GOVERNMENT OF INDIA
MINISTRY OF ENVIRONMENT & FORESTS
Central Zoo Authority

F. No. 19-256/93-CZA(193)(Vol. IV)(M)

DATE: 21.04.2014

Sub:- Proposed designs for the construction of various enclosures at Nagaland Zoological Park, Rangapahar.

2. Burmese python Exhibit:

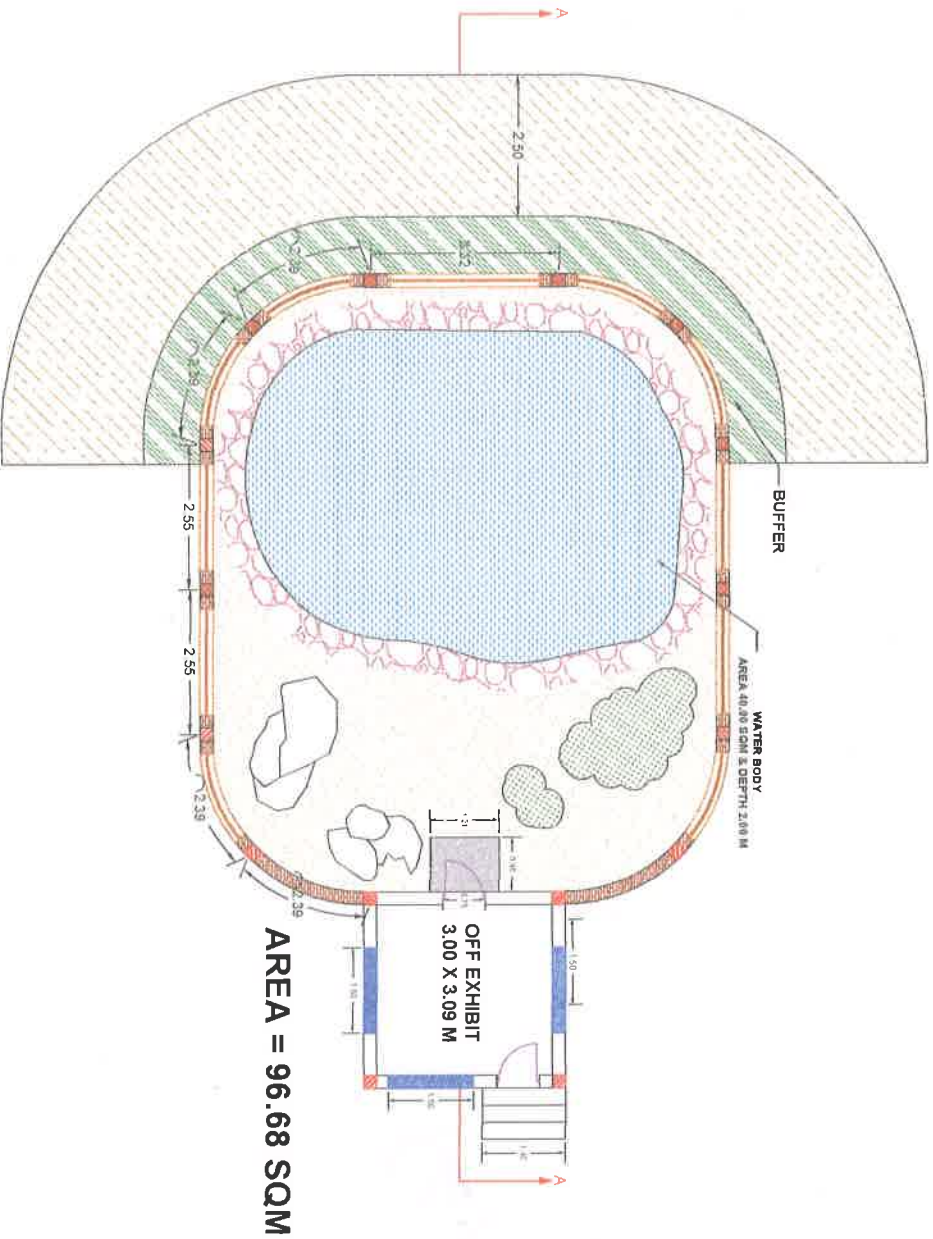
The design was scrutinized and approved subject to the following amendments:

- There is no necessity to provide off exhibit area, instead it should be treated as main exhibit area.
- The partition wall to be rounded.
- On the viewing side, toughened glass barrier should be provided and no chain link mesh to be used.

SECTION :TURTLES:NAGALAND ZOOLOGICAL PARK:RANGPAHAR

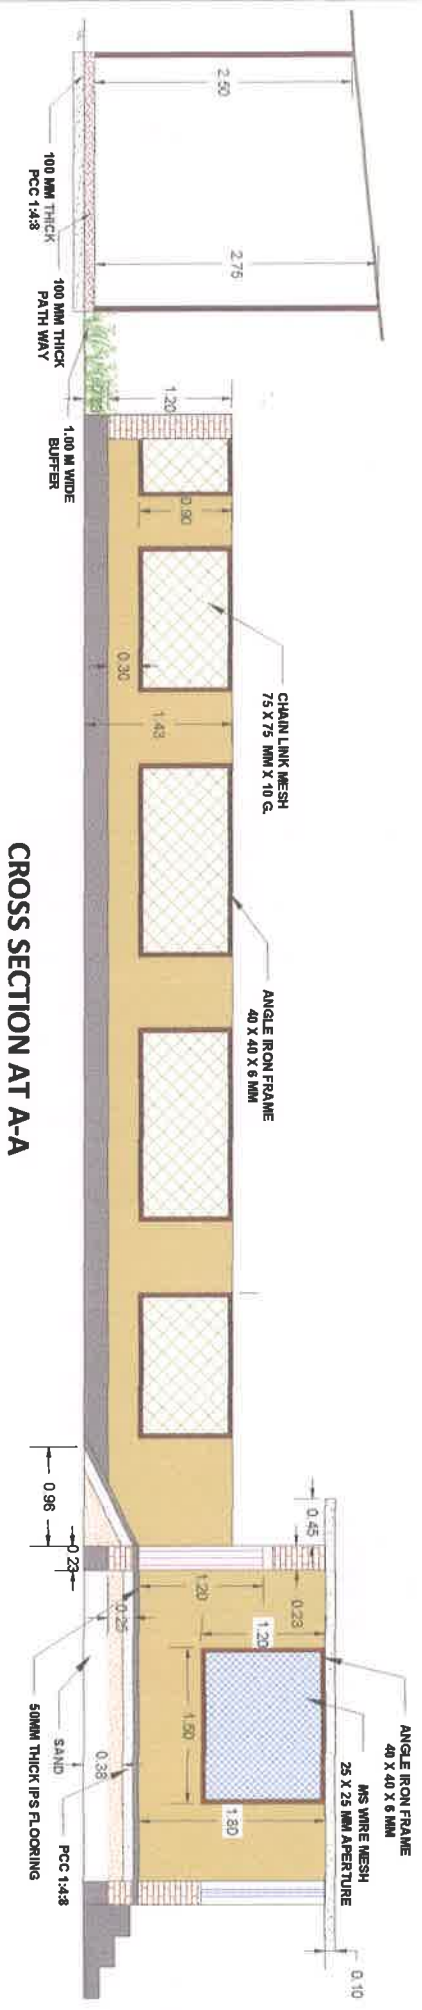
1. Turtle Exhibit:

The design was scrutinized and approved subject to the following amendments:

- The boundary wall of the paddock should be all masonry work and no chain link windows to be provided. This applies to all turtles and tortoise enclosures.
- Visitor's path should not be covered from top, instead it should be open path. This applies to all turtles and tortoise enclosures, as proposed.
